NOTICE OF DECISION
Stream Corridor Modification – 4821 E Portland Road – MISC222-0004

DECISION AND FINDINGS
Stream Corridor Modification – 4821 E Portland Road – MISC222-0004

REQUEST: Stream corridor modification related to a pump station at the Crestview Green Planned Unit Development

SHEET:
L102
 OF 10

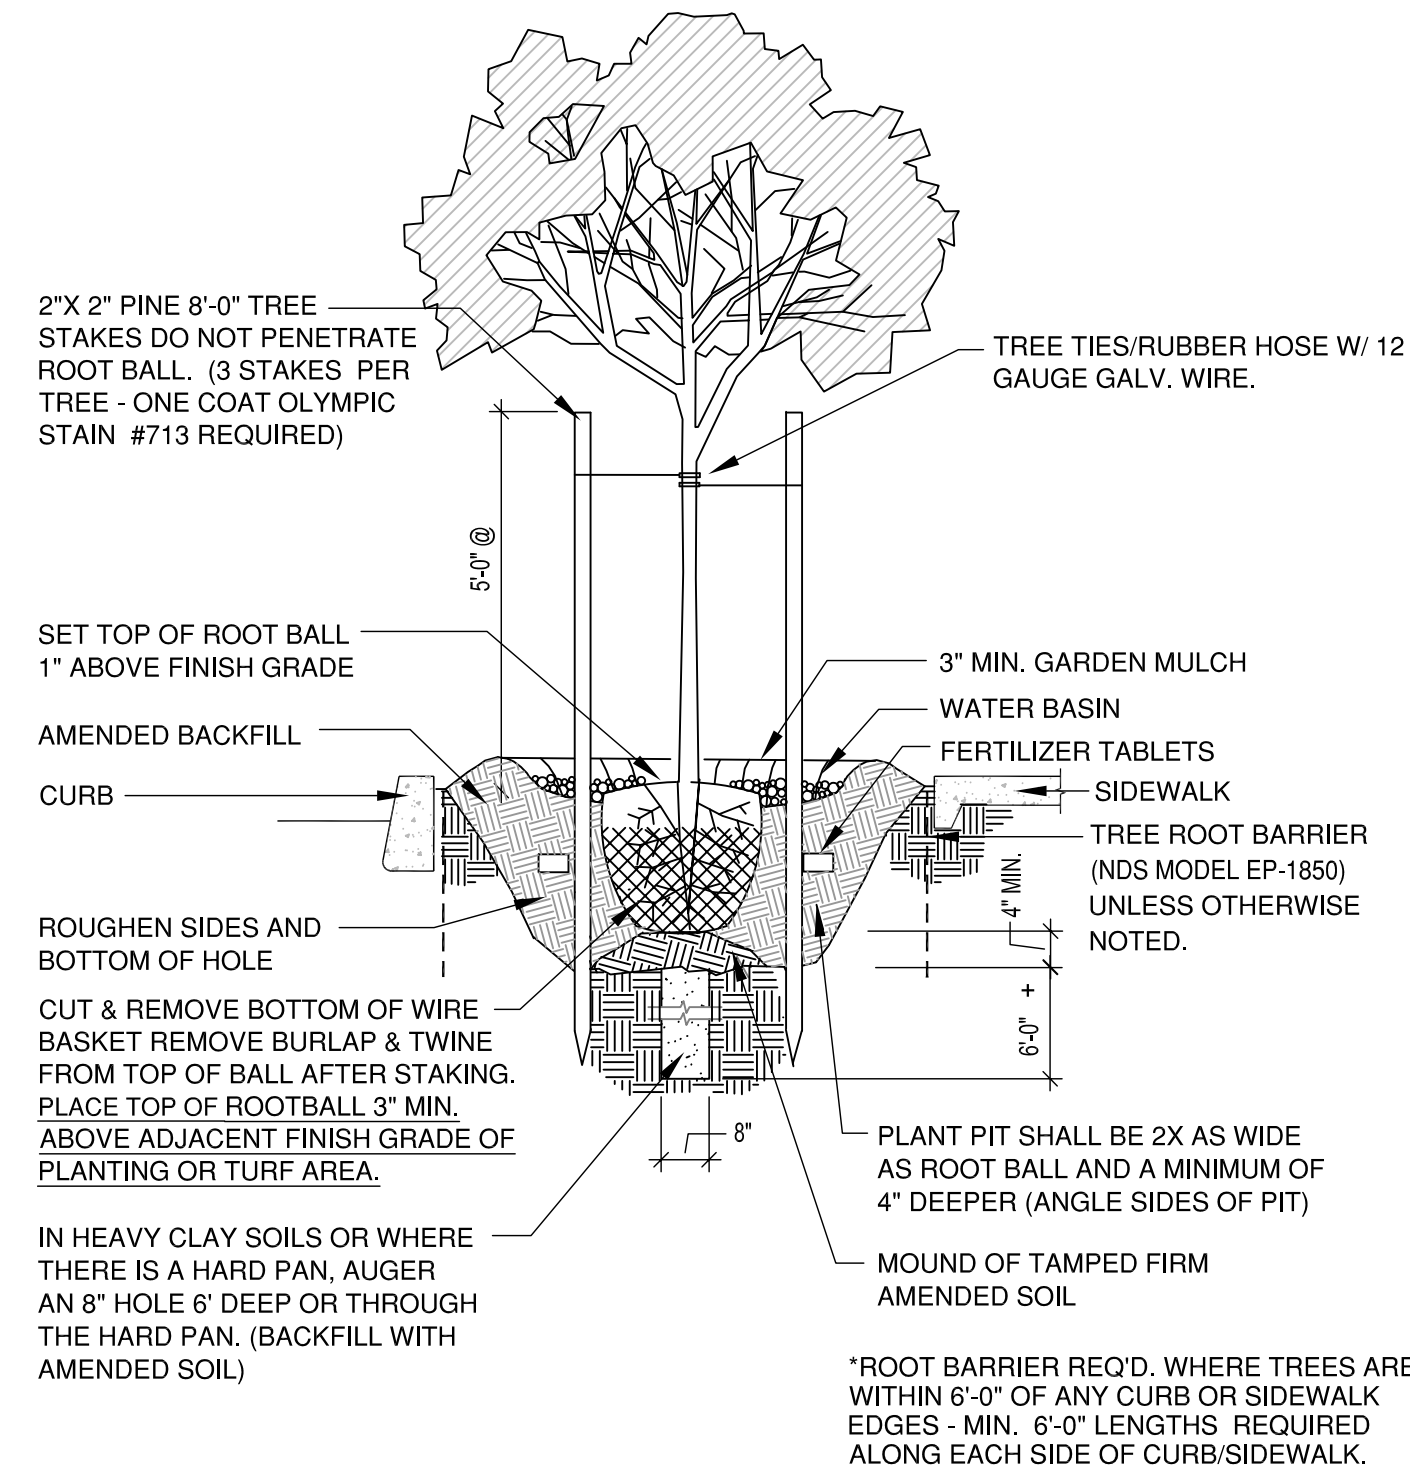
Finding: The application narrative indicates the disturbed areas will be regraded and contoured to appear natural with the contours reflected in Appendix “B” Land Use Plans, Sheet C0001. There are no notations on the Landscape Plan, Sheet 102 that any fill shall be native soil per NMC 15.342.080. The Applicant shall add a note to Sheet L102 that all fill material shall be native soil. Native soil may include soil associations commonly found within the vicinity, as identified from USDA Soil Conservation Service, Soil Survey of Yamhill Area, Oregon. The revised Landscape Plan shall be submitted to the Planning Division for review and approval prior to any grading activities and/or submittal of Building Permits.

Finding: No plant materials have been identified on the Landscape Plan per the requirement of NMC 15.342.090(B)(1). Because plants have not been identified the criterion is not met. The Applicant shall revise the Landscape Plan to identify at least 8 species of plants in conformance with NMC 15.342.090(B)(1). The revised Landscape Plan shall be submitted to the Planning Division for review and approval prior to any grading activities and/or submittal of Building Permits.

Finding: Five species of trees have been identified. No shrub species have been identified. Because no shrub species have been identified the criterion of NMC 15.342.090(B)(2) is not met. The Applicant shall revise the Landscape Plan to identify at least 2 species of plants in conformance with NMC 15.342.090(B)(2). The revised Landscape Plan shall be submitted to the Planning Division for review and approval prior to any grading activities and/or submittal of Building Permits.

Finding: Appendix “B” Land Use Plans, Sheet L102 identifies Groundcover of EcoLawn (hydroseed) within the Stream Corridor mitigation area. NMC 15.342.090(B)(3) limits no more than 50 percent of any seed mixed used can be grass. The criterion is not met. The Applicant shall revise the Landscape Plan to identify that no more than 50 percent of any seed mix used can be grass in conformance with NMC 15.342.090(B)(3). The revised Landscape Plan shall be submitted to the Planning Division for review and approval prior to any grading activities and/or submittal of Building Permits.

Finding: No information was provided on the calculation for trees and shrubs for every 500 square feet of planting area. Because no information was provided the criterion is not met. The Applicant shall revise the Landscape Plan to identify that a minimum of one tree and three shrubs shall be used for every 500 square feet of planting area in conformance with NMC 15.342.090(B)(4). The revised Landscape Plan shall be submitted to the Planning Division for review and approval prior to any grading activities and/or submittal of Building Permits.

2. The Applicant shall add a note to Sheet L102 that all fill material shall be native soil. Native soil may include soil associations commonly found within the vicinity, as identified from USDA Soil Conservation Service, Soil Survey of Yamhill Area, Oregon. The revised Landscape Plan shall be submitted to the Planning Division for review and approval prior to any grading activities and/or submittal of Building Permits.

3. The Applicant shall revise the Landscape Plan to identify at least 8 species of plants in conformance with NMC 15.342.090(B)(1). The revised Landscape Plan shall be submitted to the Planning Division for review and approval prior to any grading activities and/or submittal of Building Permits.

4. The Applicant shall revise the Landscape Plan to identify at least 2 species of plants in conformance with NMC 15.342.090(B)(2). The revised Landscape Plan shall be submitted to the Planning Division for review and approval prior to any grading activities and/or submittal of Building Permits.

5. The Applicant shall revise the Landscape Plan to identify that no more than 50 percent of any seed mix used can be grass in conformance with NMC 15.342.090(B)(3). The revised Landscape Plan shall be submitted to the Planning Division for review and approval prior to any grading activities and/or submittal of Building Permits.

6. The Applicant shall revise the Landscape Plan to identify that a minimum of one tree and three shrubs shall be used for every 500 square feet of planting area in conformance with NMC 15.342.090(B)(4). The revised Landscape Plan shall be submitted to the Planning Division for review and approval prior to any grading activities and/or submittal of Building Permits.
